CERTIFICATE OF APPROPRIATENESS

Property: 1418 Ashland Street, Lot 25, Tract 24 and 26A, Block 152, Houston Heights Subdivision. The property includes a historic 1,194 square foot single family residence situated on a 8,712 square foot (66' x 132') interior lot.

Proposal: Alteration – Addition

The applicant proposes to construct a two-story 2,613 square foot addition to the rear of a one-story 1,194 square foot Contributing residence.

NORTH SIDE ELEVATION

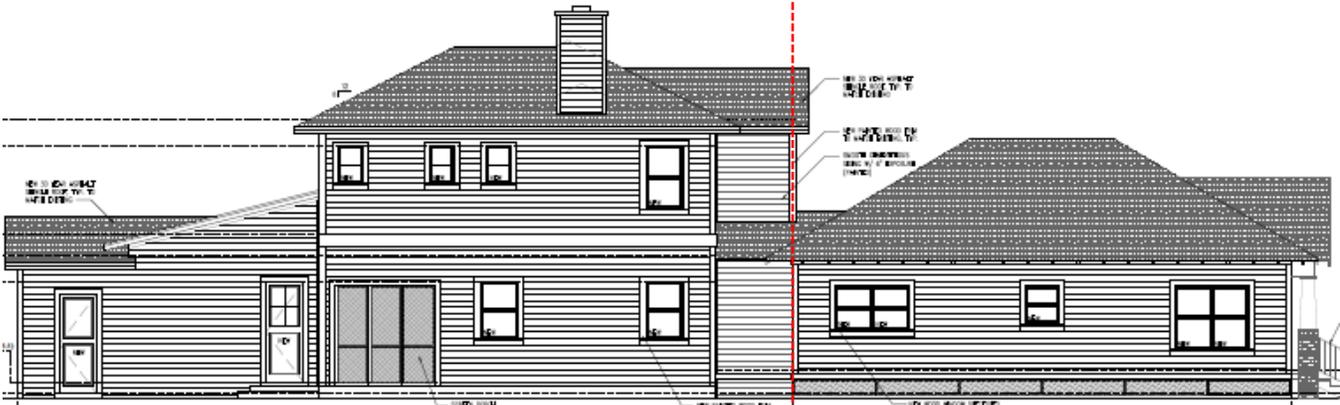
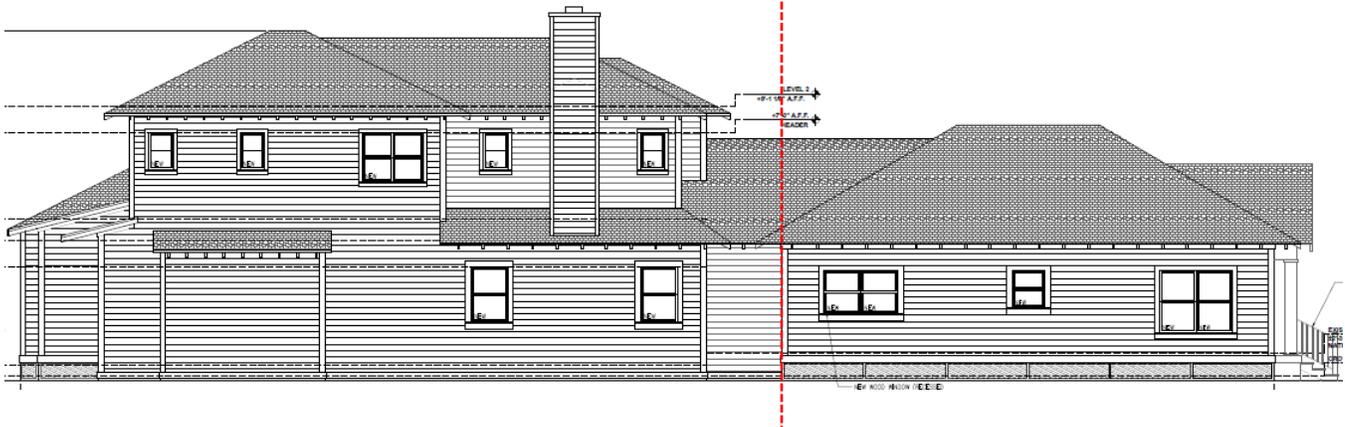
Side Elevation: The applicant proposes to replace four non-original aluminum windows with five wood 1-over-1 windows. The window opening at the rear of the north elevation will be widened to convert the window opening from single to double. Staff inspection found that the structural wall material at the proposed opening has long since been removed meaning the enlarged opening will not result in the loss of historic materials.

The addition will start at the rear of the existing structure. The addition will feature a pair of windows and a side screened porch on the first floor and 4 windows on the second floor.

FIRST FLOOR PLAN

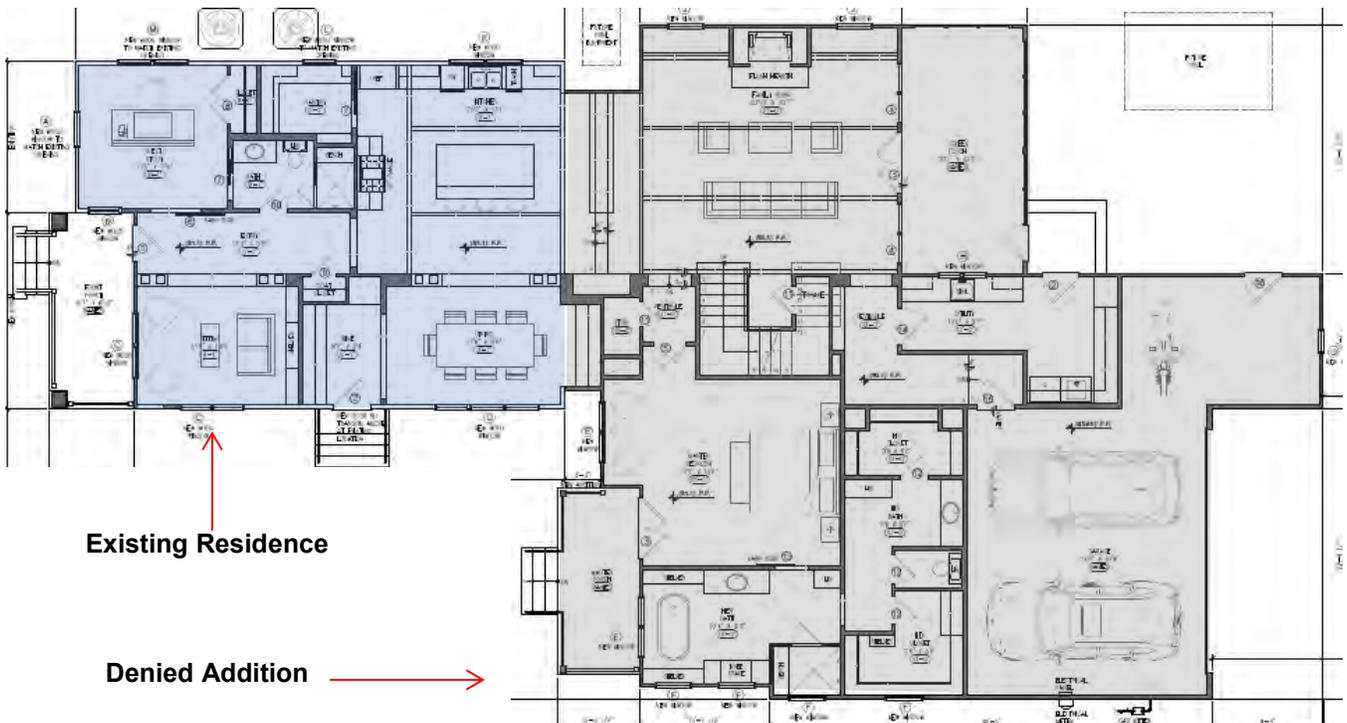
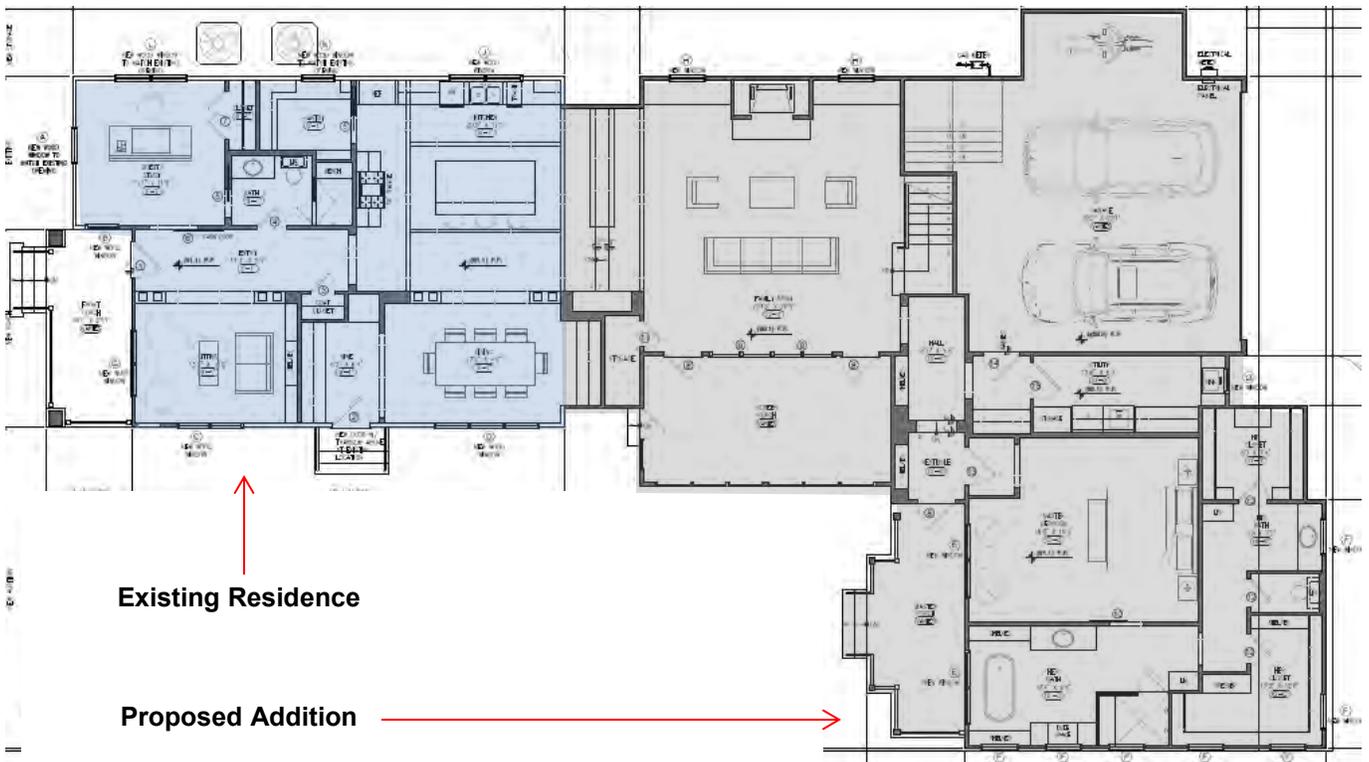
Proposed: The addition has been revised so that more of the mass is located at the rear of the property behind the existing structure. On the north side, the addition has been reduced in width by approximately 3' so that the north facing wall is parallel with the existing north facing wall behind the proposed hyphen. On the south side, the addition has been moved back approximately 25' from the front of the street. This gives the south side portion of the addition the appearance of a one-story secondary structure at the rear of the lot. The revised addition will measure 59' wide by 55' 5" deep with an eave height of 21' 1" and a ridge height of 28' 6".

**HISTORIC STRUCTURAL WALL MATERIAL PREVIOUSLY REMOVED AT PROPOSED
NEW WINDOW OPENINGS**
EXISTING WINDOWS C AND D

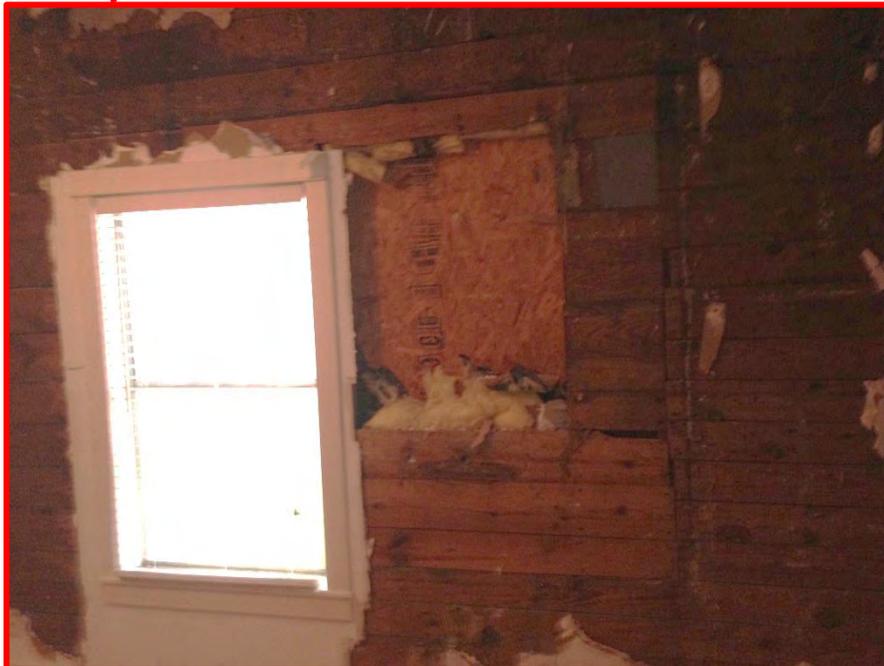
Side Elevation: The applicant proposes to replace two non-original aluminum windows with an adjoining pair of wood windows and an adjoining trio of wood windows. Staff inspection found that the historic studs and shiplap have long since been removed at these locations so the enlarged window openings will not result in a loss of any historic materials. A non-original side door will be replaced by a new 4-lite wood door. A set of wood steps and wood square railings will be installed to access the side entrance. The addition will feature four single-lite casement windows at the first floor and a row of three adjoining single-lite casement windows on the second floor.
